SUBJECT: ISSUANCE OF AMENDMENT NO. 115 TO FACILITY OPERATING LICENSE NPF-9 AND  
AMENDMENT NO. 97 TO FACILITY OPERATING LICENSE NPF-17 - MCGUIRE  
NUCLEAR STATION, UNITS 1 AND 2 (TACS 77546/77547)

The amendments replace the existing McGuire Units 1 and 2 reactor coolant system heatup and cooldown limit curves with revised curves (TS Figures 3.4-2, 3.4-3, 3.4-4 and 3.4-5), as well as revise the reactor vessel surveillance capsule withdrawal schedule (TS Table 4.4-5).

SAFETY EVALUATION BY THE OFFICE OF NUCLEAR REACTOR REGULATION  
RELATED TO AMENDMENT NO. 115 TO FACILITY OPERATING LICENSE NPF-9  
AND AMENDMENT NO. 97 TO FACILITY OPERATING LICENSE NPF-17  
DUKE POWER COMPANY  
DOCKET NOS. 50-369 AND 50-370  
MCGUIRE NUCLEAR STATION, UNITS 1 AND 2

FIGURE 3.4-2

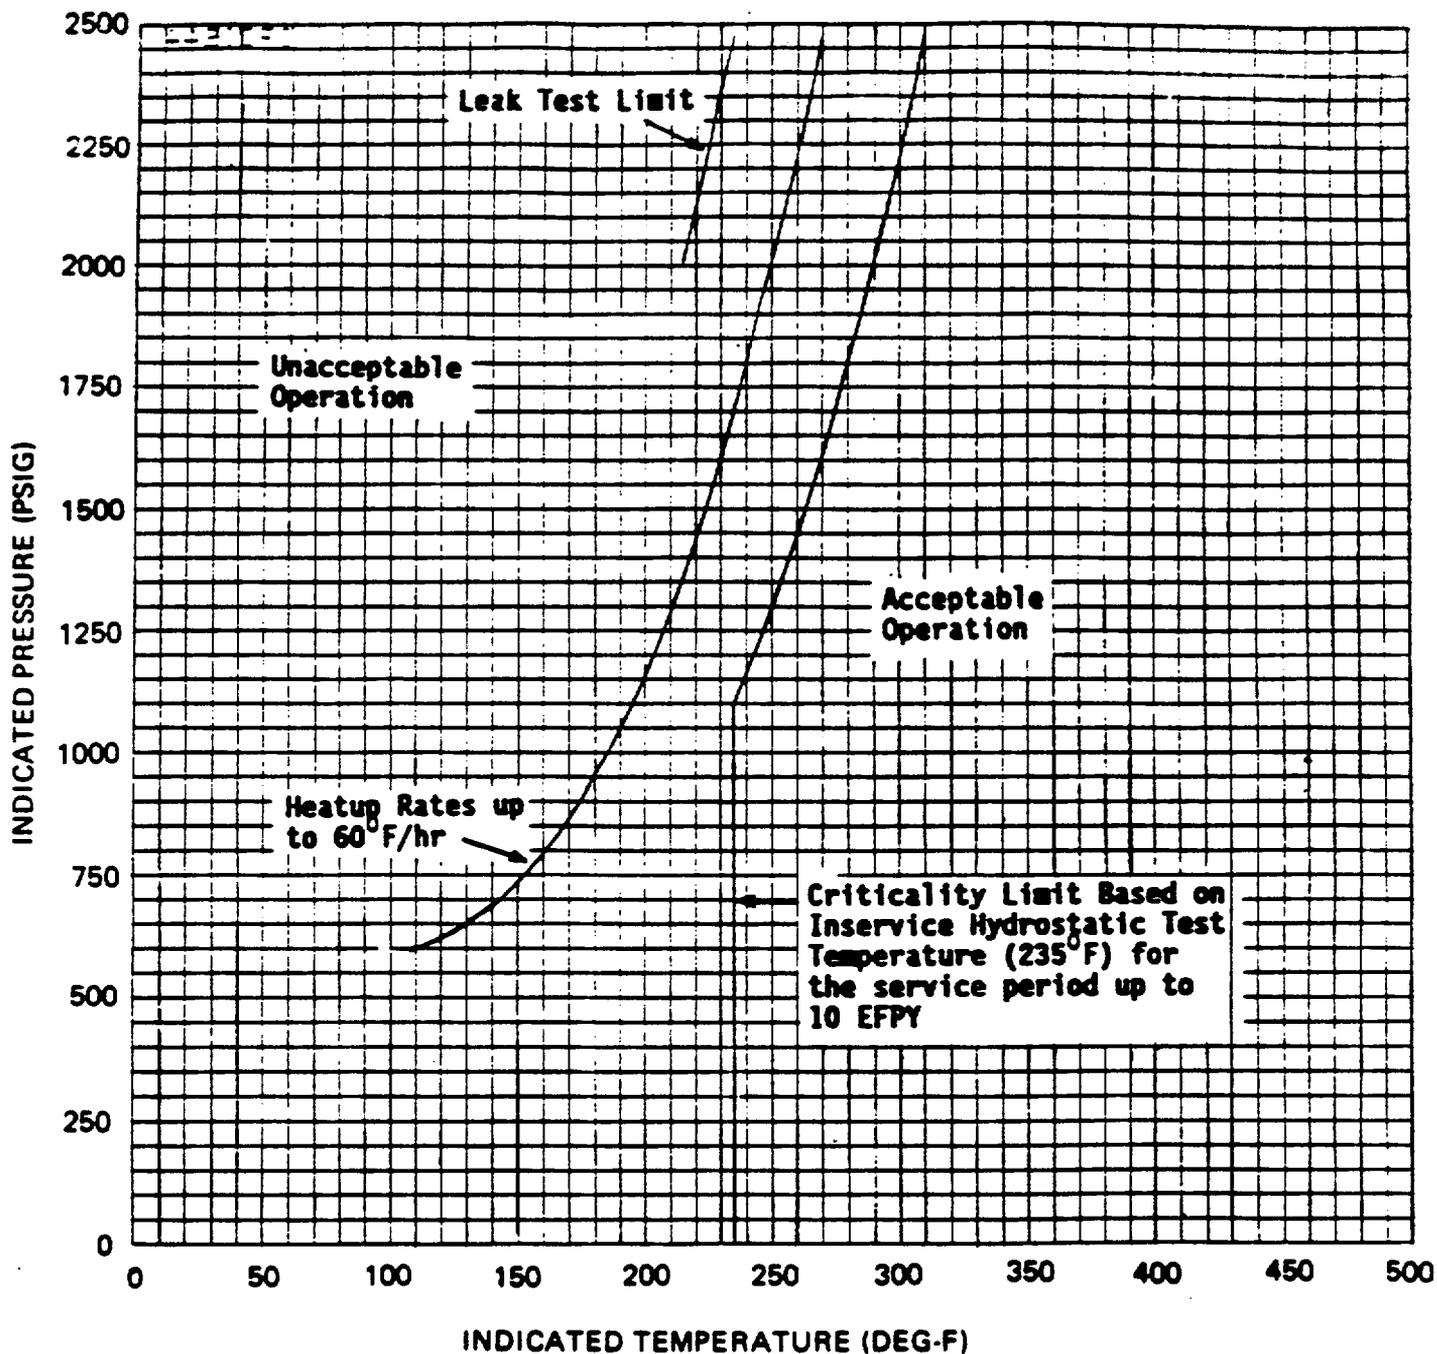
CURVE APPLICABLE FOR HEATUP RATES UP TO 60°F/HR FOR THE SERVICE PERIOD UP TO 10 EFPY. CONTAINS MARGINS OF 10°F AND 60 PSIG FOR POSSIBLE INSTRUMENT ERRORS.

MATERIAL BASIS  
 CONTROLLING MATERIAL—LONGITUDINAL  
 COPPER CONTENT: 0.21 wt% WELD  
 RT NDT INITIAL: -50°F  
 RT NDT AFTER 10 EFPY: 1/4T, 185.5°F  
 3/4T, 113°F

The licensee calculated the ARTs of  $165.5^{\circ}F$  at  $1/4T$  and  $113^{\circ}F$  at  $3/4T$  for the same limiting material, longitudinal weld seam M1.22. The licensee's ARTs are more conservative than the staff's ARTs and, therefore, are acceptable. Substituting the ART of  $165.5^{\circ}F$  into the equations in SRP 5.3.2, the staff verified that the proposed P/T limits for heatup, cooldown, and hydrotest meet the beltline material requirements in Appendix G of 10 CFR Part 50.

FIGURE 3.4-3

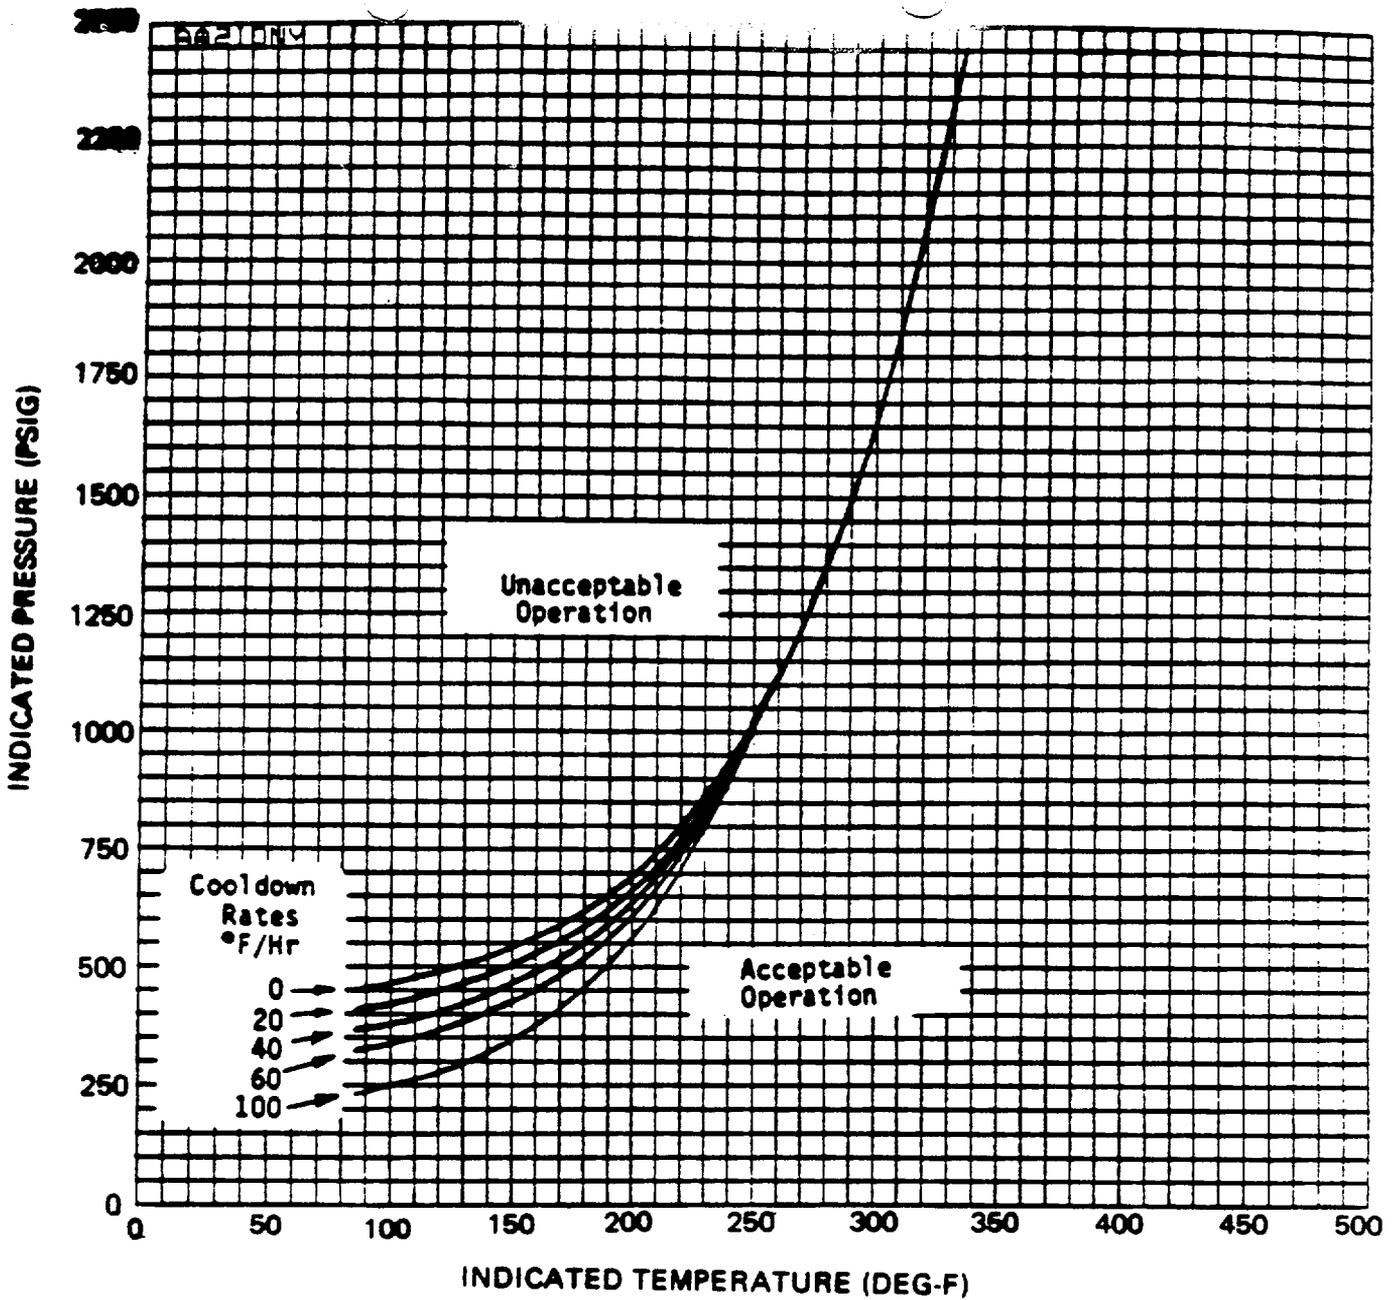
CURVES APPLICABLE FOR HEATUP RATES UP TO 60°F/HR FOR THE SERVICE PERIOD UP TO 10 EFPY. CONTAINS MARGINS OF 10°F AND 60 PSIG FOR POSSIBLE INSTRUMENT ERROR.

MATERIAL BASIS  
 CONTROLLING MATERIAL: LOWER SHELL  
 COPPER CONTENT: 0.15w%  
 RTNDT INITIAL: -30°F  
 RTNDT AFTER 10 EFPY: 1/4T, 90°F  
 3/4T, 81°F

The licensee calculated an ART of  $90^{\circ}F$  at  $1/4T$  for the same limiting forging. The staff judges that the licensee's ART of  $90^{\circ}F$  is more conservative than the staff's ART of  $89.6^{\circ}F$ , and it is acceptable. Substituting the ART of  $90^{\circ}F$  into equations in SRP 5.3.2, the staff verified that the proposed P/T limits for heatup, cooldown, and hydrotest meet the beltline material requirements in Appendix G of 10 CFR Part 50.

FIGURE 3.4-4 MCGUIRE UNIT 1, REACTOR COOLANT SYSTEM, COOLDOWN LIMITATIONS  
 NRC RG 1.90 REV 2  
 APPLICABLE FOR THE FIRST 10 EFPY

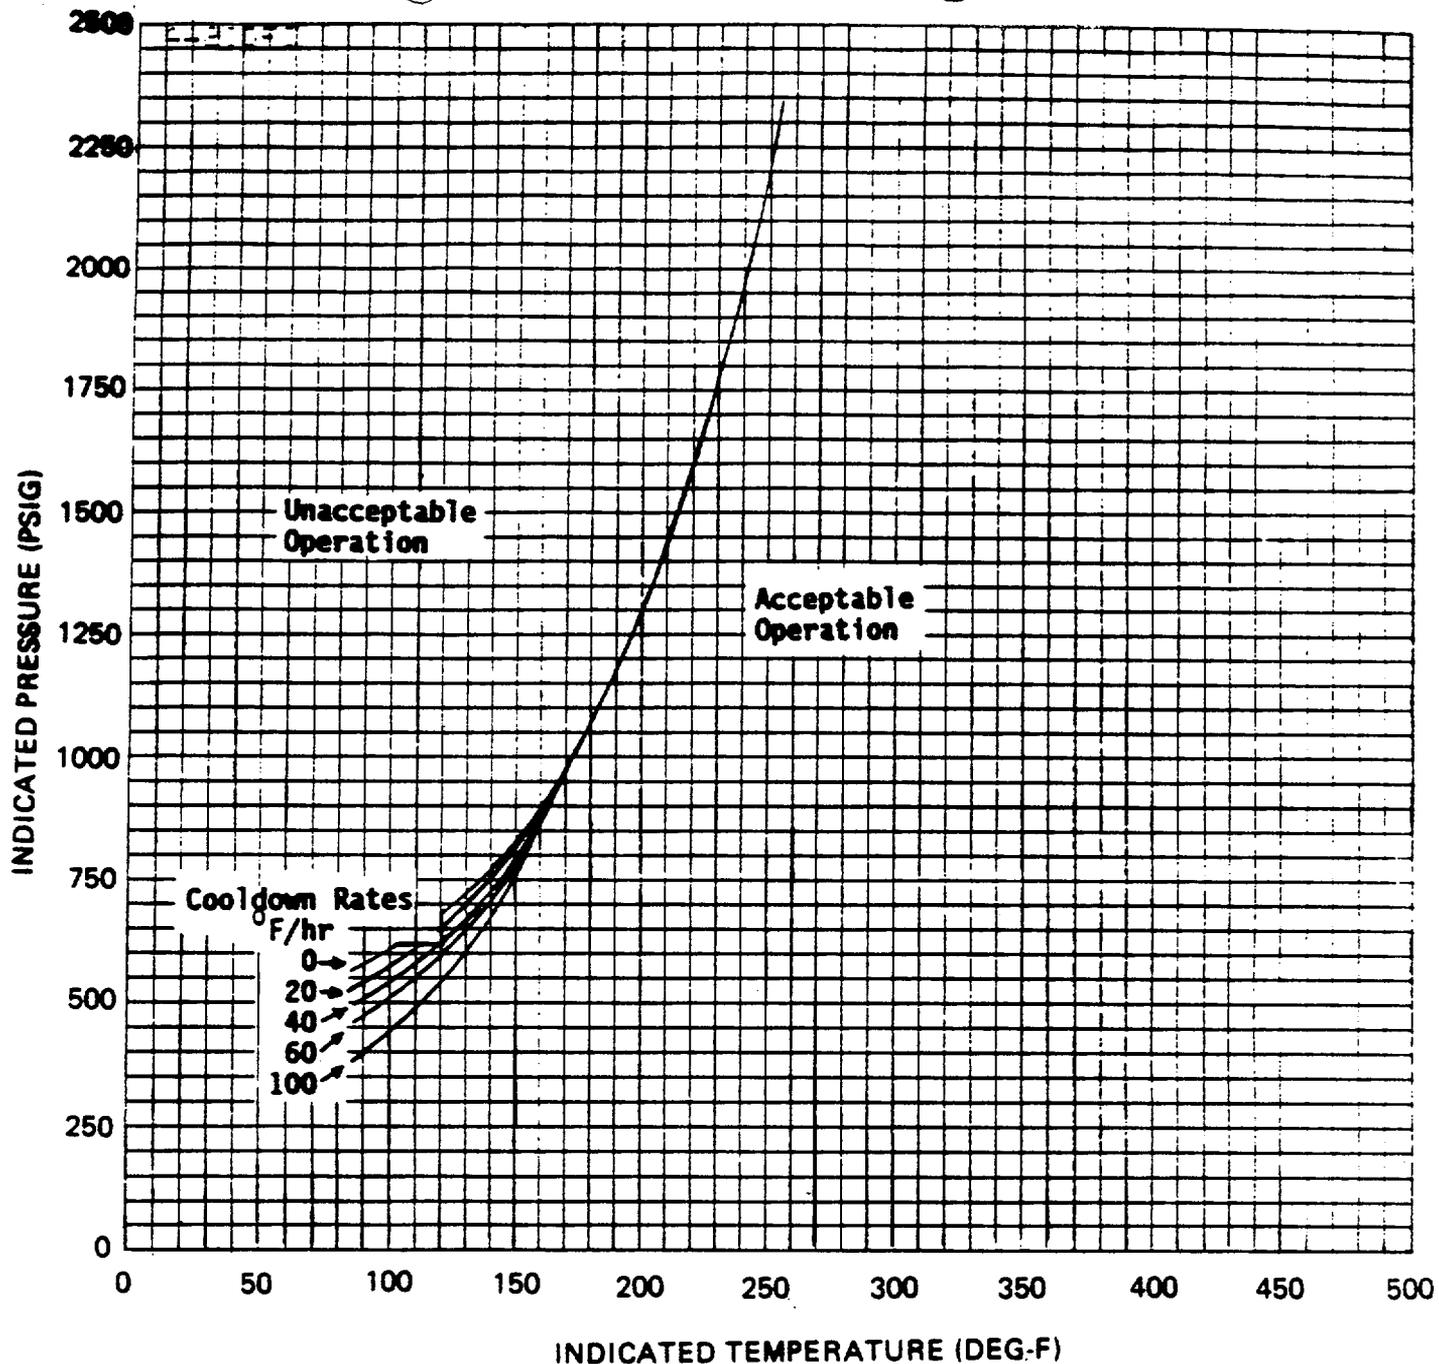
CURVE APPLICABLE FOR COOLDOWN RATES UP TO 100 °F/HR FOR THE SERVICE PERIOD UP TO 10 EFPY. CONTAINS MARGINS OF 10 °F AND 60 PSIG FOR POSSIBLE INSTRUMENT ERROR.

MATERIAL BASIS  
 CONTROLLING MATERIAL - LONGITUDINAL  
 COPPER CONTENT: 0.21 wt% WELD  
 RT NDT INITIAL: -50 °F  
 RT NDT AFTER 10 EFPY: 1/4T, 166.5 °F  
 3/4T, 113 °F
